Accessibility Survey

City of Downey Gallatin Road & Paramount Boulevard

Date of Inspection 4/14/2017

Disability Access Consultants

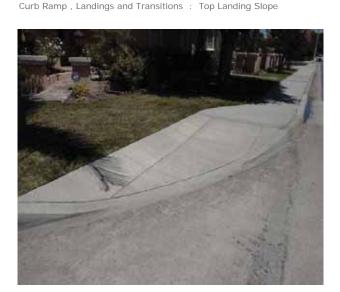
The slope at the top landing is greater than allowed.

On-Site Finding 2.70 percent

Provide a top landing surface that does not exceed the maximum slope and cross slope. Provide a sufficient maneuvering clearance that does not accumulate water.

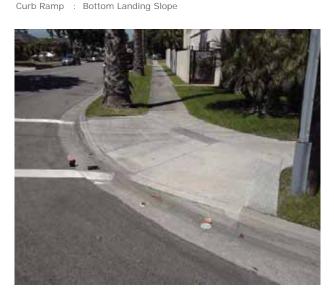
The bottom landing of the curb ramp is on the street, and the slope of the bottom landing is not compliant.

On-Site Finding 12.10 percent

Ensure the bottom landing slope is compliant and provides a smooth transition.

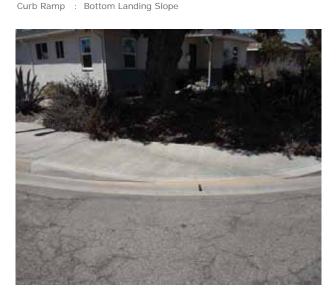
The bottom landing of the curb ramp is on the street, and the slope of the bottom landing is not compliant.

On-Site Finding 11.00 percent

Ensure the bottom landing slope is compliant and provides a smooth transition.

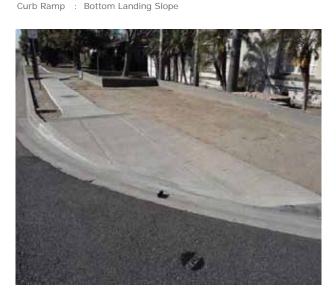
The bottom landing of the curb ramp is on the street, and the slope of the bottom landing is not compliant.

On-Site Finding 13.10 percent

Ensure the bottom landing slope is compliant and provides a smooth transition.

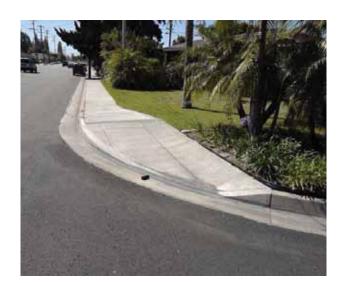
The curb ramp does not provide a detectable warning surface which includes truncated domes.

On-Site Finding Not Found

Provide compliant detectable warnings to surface.

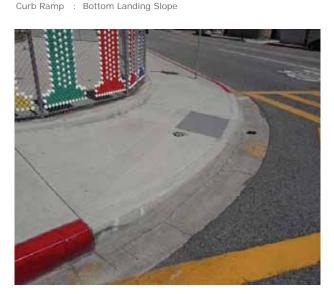
The bottom landing of the curb ramp is on the street, and the slope of the bottom landing is not compliant.

On-Site Finding 7.30 percent

Ensure the bottom landing slope is compliant and provides a smooth transition.

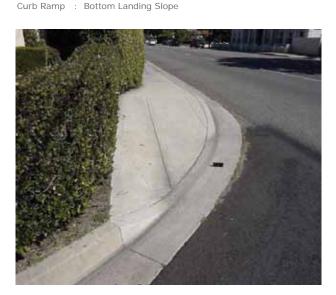
The bottom landing of the curb ramp is on the street, and the slope of the bottom landing is not compliant.

On-Site Finding 13.20 percent

Ensure the bottom landing slope is compliant and provides a smooth transition.

Change in Level West of Lakewood Boulevard @ 33.955937697817, - 118.115896582603

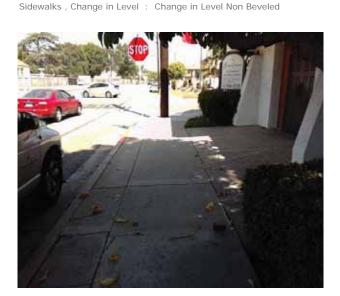
There is a change in elevation greater than recommended value.

On-Site Finding 1.00 inches

Ensure that the change in elevation is within the recommended value.

Change in Level West of Stoakes Avenue @ 33.958418319055, -118.118796050549

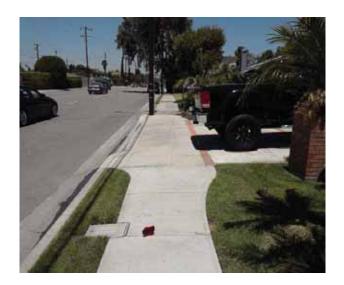
There is a change in elevation greater than recommended value.

On-Site Finding 0.37 inches

Ensure that the change in elevation is within the recommended value.

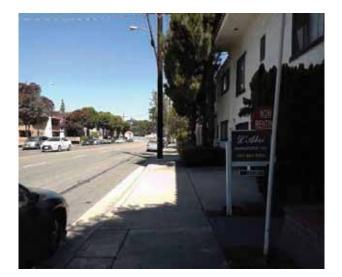
There are no detectable warnings where the pedestrian route crosses vehicular traffic.

On-Site Finding Not Found

Provide detectable warnings.

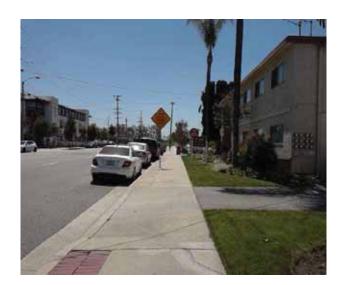
On-Site Finding Not Found

Provide detectable warnings.

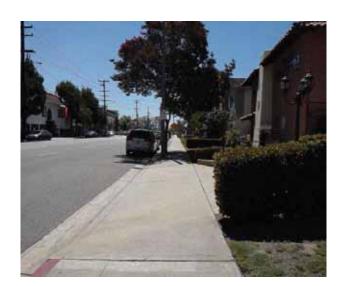
On-Site Finding Not Found

Provide detectable warnings.

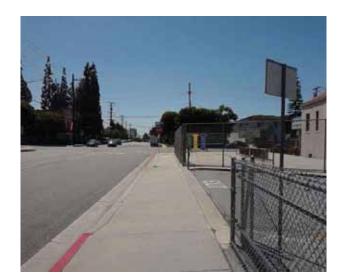
There are no detectable warnings where the pedestrian route crosses vehicular traffic.

On-Site Finding Not Found

Provide detectable warnings.

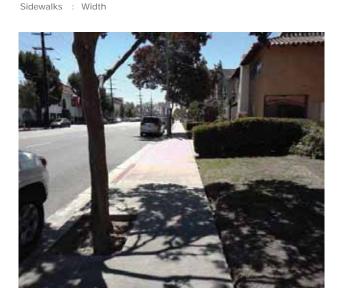
Sidewalk does not have enough width.

On-Site Finding 47.00 inches for 4.00 feet

Widen the sidewalk to the recommended value.

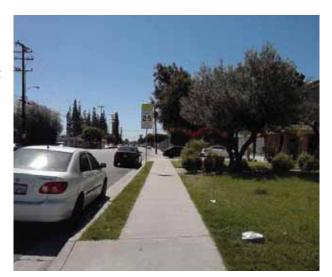
Sidewalk cross slope is not compliant.

On-Site Finding 3.00 percent for 174.00 feet

Repave the sidewalk surface with the recommended cross slope.

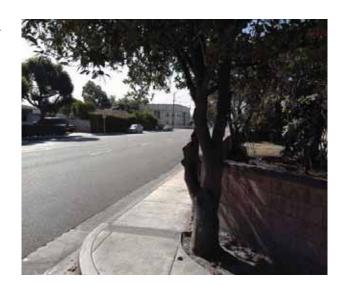
Overhead obstruction height is not compliant.

On-Site Finding 42.00 inches

Provide a compliant vertical clearance height.

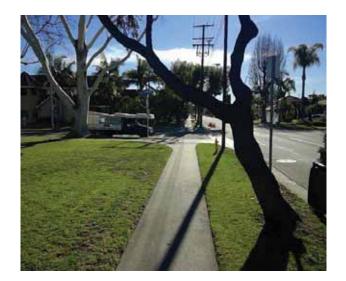
Overhead obstruction height is not compliant.

On-Site Finding 70.00 inches

Provide a compliant vertical clearance height.
